A47 Wansford to Sutton Dualling

Scheme Number: TR010039

June 2022
Deadline 8

**9.35 ENVIRONMENTAL STATEMENT
ADDENDUM ONE**

DRAWING TITLE
ENVIRONMENTAL MASTERPLAN SHEET 3 OF 7

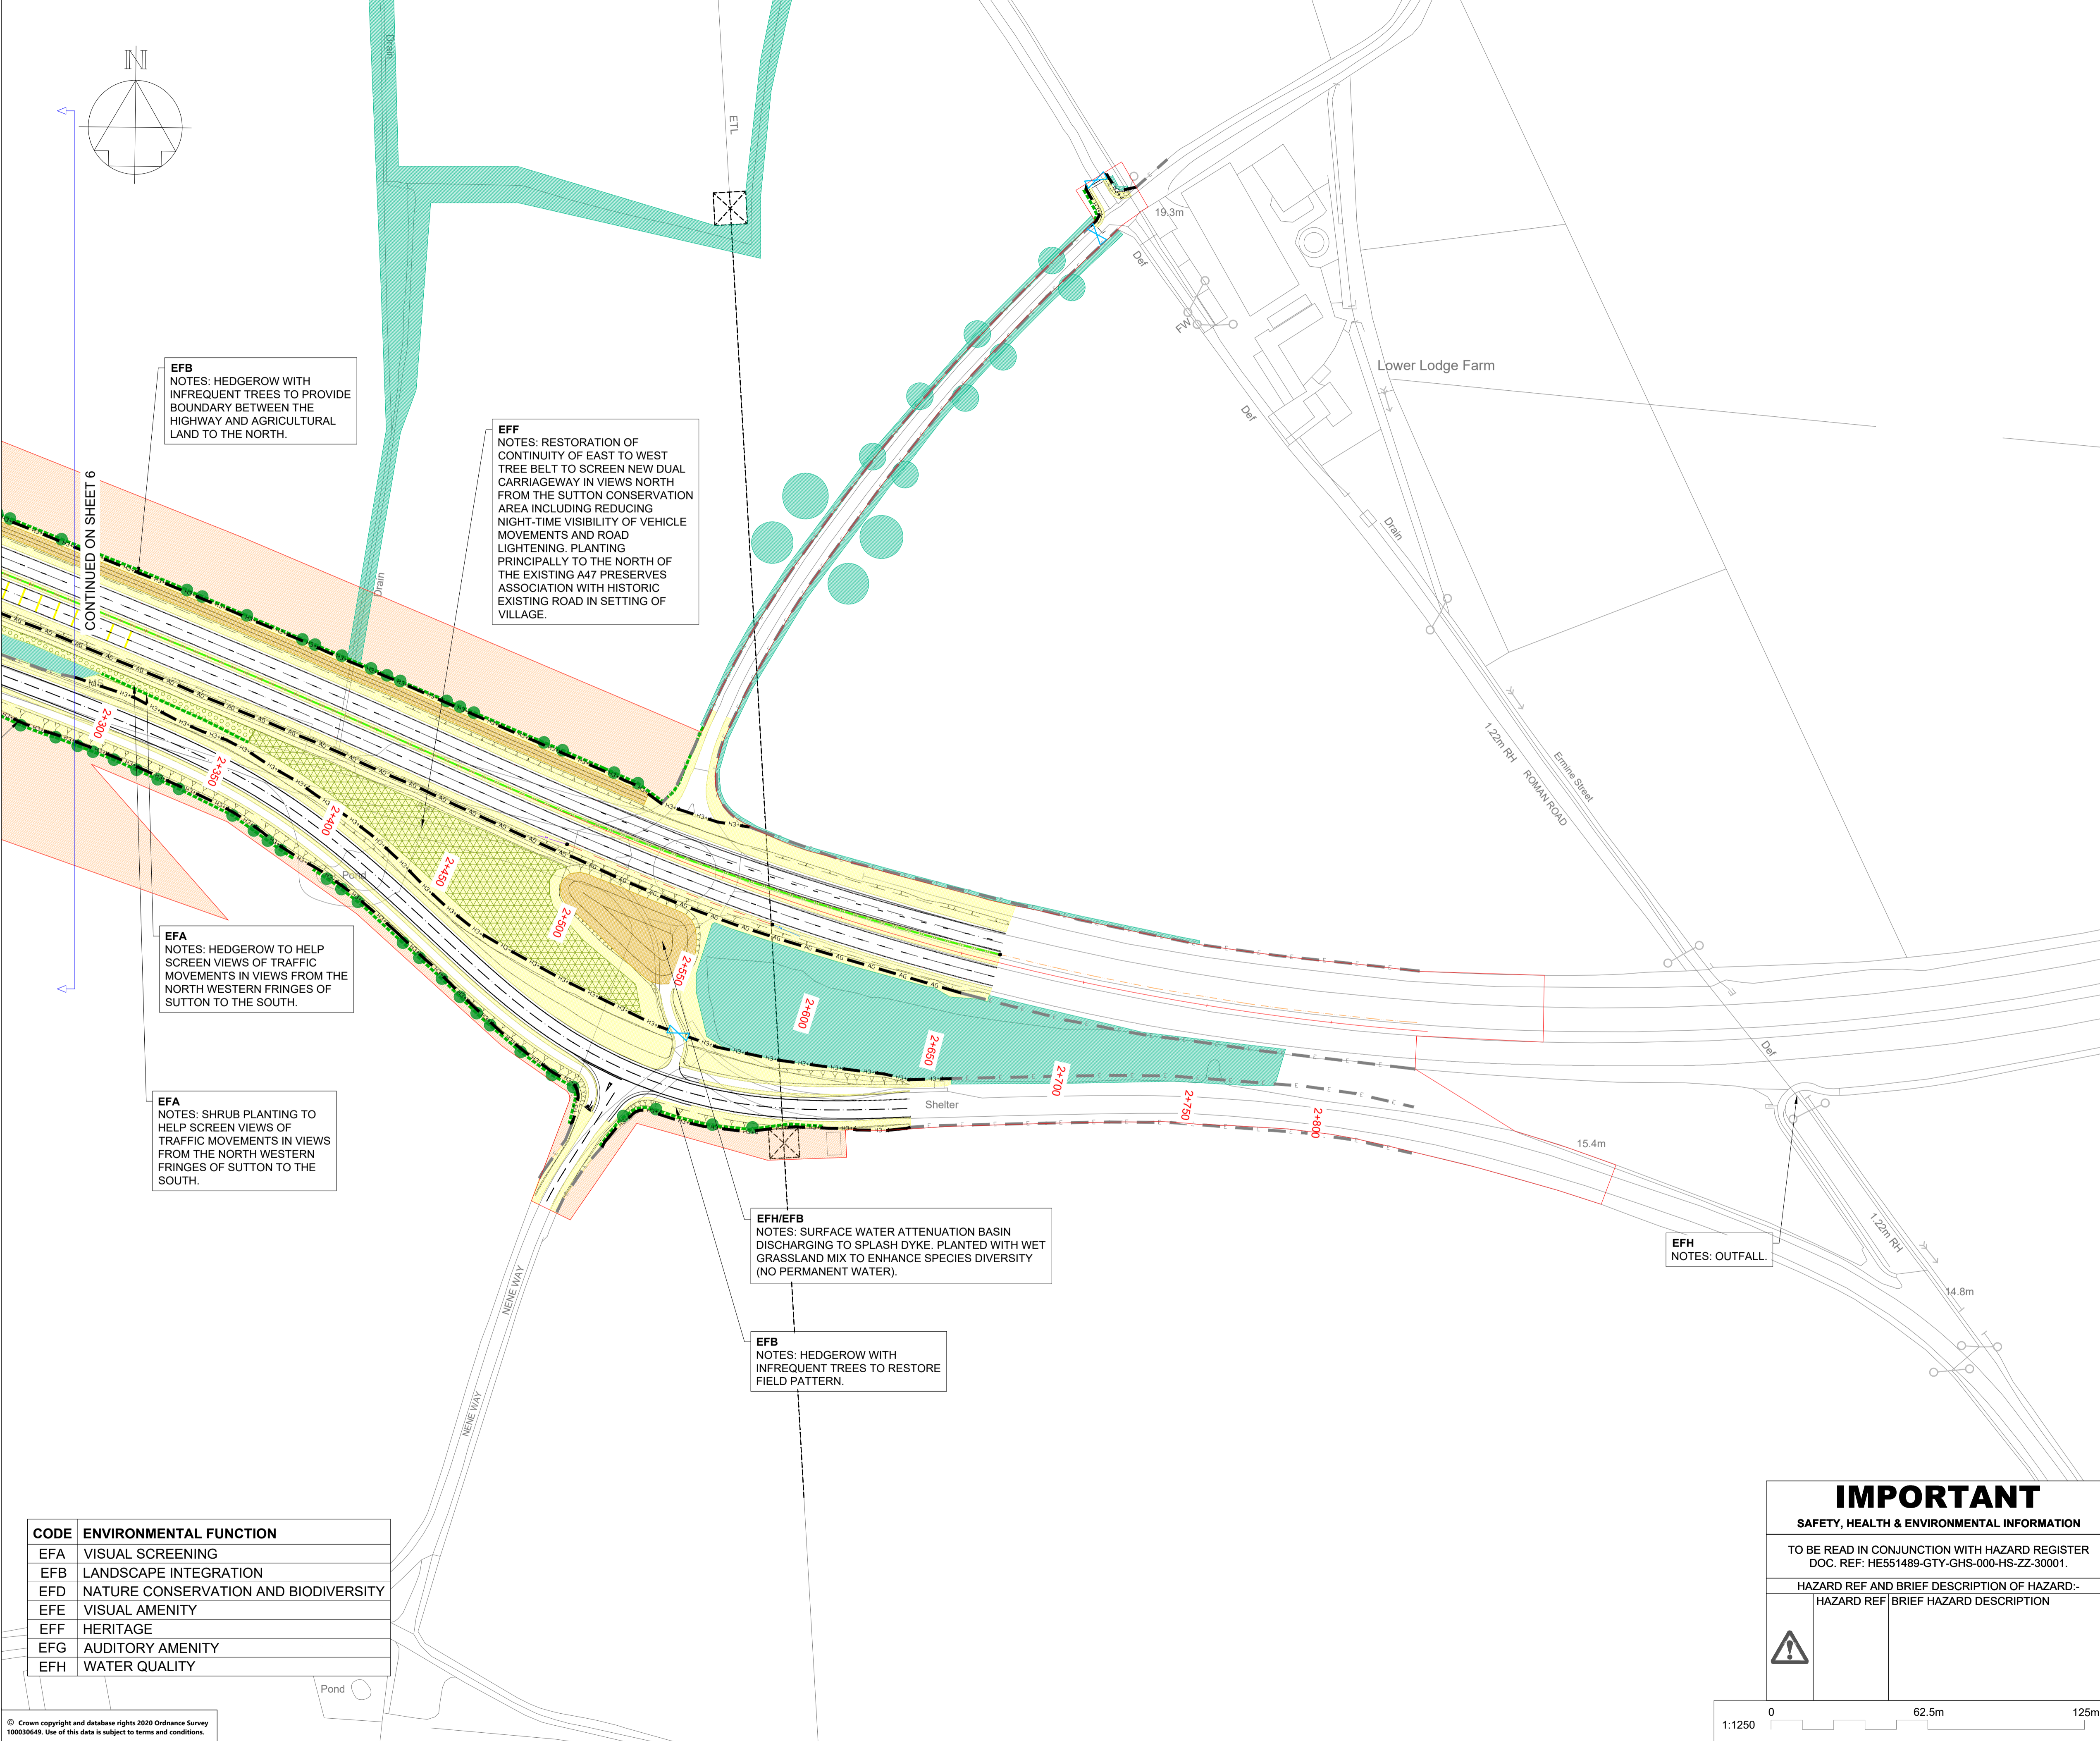
- 2.2.1. The Applicant has carried out a detailed review of the construction phasing requirements associated with utility diversions in this location and proposes to move the westbound off-slip (Work no. 15) 14 m to the north. The purpose of this proposed change is to achieve a more efficient interface between the Scheme and assets belonging to Anglian Water, Western Power Distribution, Gigaclear, Openreach, Vodafone and GTT.
- 2.2.2. The findings and conclusions of each ES Chapter are to be reviewed against this design change to determine whether there are no new or different likely significant effects than those previously reported in the ES due to this design change.
- 2.2.3. This design change is illustrated in the Environmental Masterplan Rev 3 [TR010039/APP/6.8 Rev 3].

- 2.3.2. The change will result in a more efficient design, taking into account objectives (a) to (c) above.
- 2.3.3. The proposed modification will consist of changes to the alignment of the access to Sacrewell Farm as shown on the Environmental Masterplan [TR010039/APP/6.8 Rev 3].
- 2.3.4. The findings and conclusions of each ES Chapter are to be reviewed against this design change to determine whether there are no new or different likely significant effects than those previously reported in the ES due to this design change.
- 2.3.5. This design change is illustrated in the Environmental Masterplan Rev 3 [TR010039/APP/6.8 Rev 3].

- 3.4.2. The change to the alignment of the westbound off-slip places the local access road to the north of the open space and former picnic site adjacent the River Nene (linking to both Sacrewell Farm and to the petrol station) approximately 14 m further north. This places the alignment closer to the proposed alignment of the main A47 carriageways to the north and further away from the River to the south. In doing so the new alignment runs at a slightly higher elevation on this gently sloping ground and does not make use of the area of existing hardstanding which runs along the northern edge of the riverside open space and former picnic site (a former road). As a consequence, this linear area of existing hardstanding would remain in situ and would run parallel to the new road. The retained area of hardstanding would be used to provide maintenance access to land to the west.

- 3.4.5. The change to the alignment of the proposed new access road into Sacrewell Farm would introduce a gently curving alignment in cutting which would pass through the existing woodland belt which lies to the west of the existing access road into Sacrewell Farm.

3.4.11. The Design Change Two proposed alternate layout for Scarewell Road however, does have implications for the extent of tree retention and tree removal detailed within ES Appendix 7.6: Arboricultural Impact Assessment [REP4-007]. The vegetation affected by the proposed amendment comprises four groups of trees recorded as G10, G11, G12 and G13 within ES Appendix 7.6: Arboricultural Impact Assessment [REP4-007]
